Access Compliance Report

Public Rights-of-Way

Intersection ID: 17150	Main Street: QUEEN_CHARLOTTE'S_CT	Cross Street: WATER_OAK_RD	Location: SW
ADA ID: F5DDF31DB8D6	Ramp Type: BlendTrans2	Initial Pass/Fail: Fail	Overall Compliance: No
		Severity Score: 10

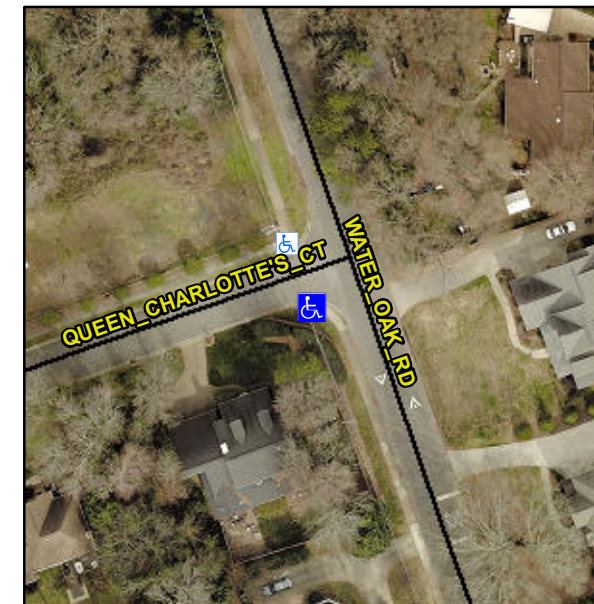
Not Found, R304.5.1, R304.5.3

Compliance	Description	Data	Compliance	Description	Data
N/A	Ramp Length (in)	61.0	Yes	BlendTrans Slope (%)	4.1
No	Ramp Width (in)	44.0	No	BlendTrans XSlope (%)	2.2
N/A	Flare Type LT	N/A	N/A	Flare Type RT	N/A
N/A	Flare Slope LT (%)	N/A	N/A	Flare Slope RT (%)	N/A
N/A	Flare Traversable LT?	N/A	N/A	Flare Traversable RT?	N/A
N/A	Landing Length (in)	N/A	N/A	DWS Provided?	N/A
N/A	Landing Width (in)	N/A	N/A	DWS Contrast?	N/A
N/A	Landing Slope (%)	N/A	N/A	DWS Length (in)	N/A
N/A	Landing X Slope (%)	N/A	N/A	DWS Full Width?	N/A
N/A	Landing Curb? (Y/N)	N/A	N/A	DWS Offset (in)	N/A
N/A	Shared Landing?	N/A			
N/A	Gutter Ponding?	N/A	N/A	Gutter Slope (%)	N/A
N/A	Gutter Lip Ht (in)	N/A	N/A	Gutter X Slope (%)	N/A
N/A	Painted X Walk1?	No	N/A	Painted X Walk2?	No
	X Walk 1 Direction	To E		X Walk 2 Direction	To NW
	X Walk 1 Width (in)	N/A		X Walk 2 Width (in)	N/A
	X Walk 1 Slope (%)	2.1		X Walk 2 Slope (%)	1.6
	X Walk 1 X Slope (%)	3.2		X Walk 2 X Slope (%)	0.1

N/A	Ramp inside XWalk1?	N/A	N/A	Ramp inside XWalk2?	N/A
	Road Slope (%)	1.3		Clear Space?	N/A
	Road X Slope (%)	1.5	N/A	Clear Space to XWalk (in)	N/A
N/A	Any Obstructions?	N/A	N/A	Storm Grate/Utility Hazard?	N/A
	Obstruction Type			Storm Grate/Utility Type	
		N/A			N/A
			Yes	Surface Condition? (G/P)	Good
			No	Curb Slope (%)	10.5

Remove & Replace Curb Ramp With Two New Directional Ramps or Equivalent.
